SIX MONTHLY ENVIRONMENTAL PERFORMANCE AUDIT, STAGE C1 IVANHOE ESTATE, MACQUARIE PARK NSW FRASERS PROPERTY AUSTRALIA PTY LIMITED

9 MAY 2023 123004R01 VERSION 1

Environmental management system (EMS) audit at Stage C1 Ivanhoe Estate, Macquarie Park, NSW

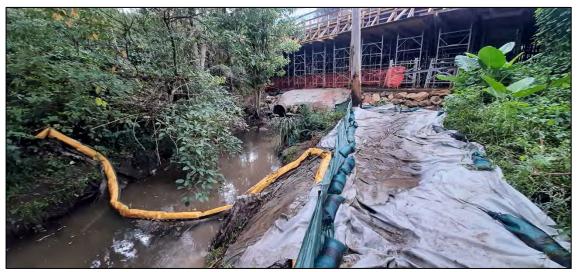
16. Downstream Shrimptons Creek – Water appeared clear with no signs of algae, visual and / or olfactory signs of contamination. collapsed silt fences noted. 15/03/2023

Collapsed siltfences noted along western bank of Shrimptons Creek – downstream from bridgeworks. 15/03/2023
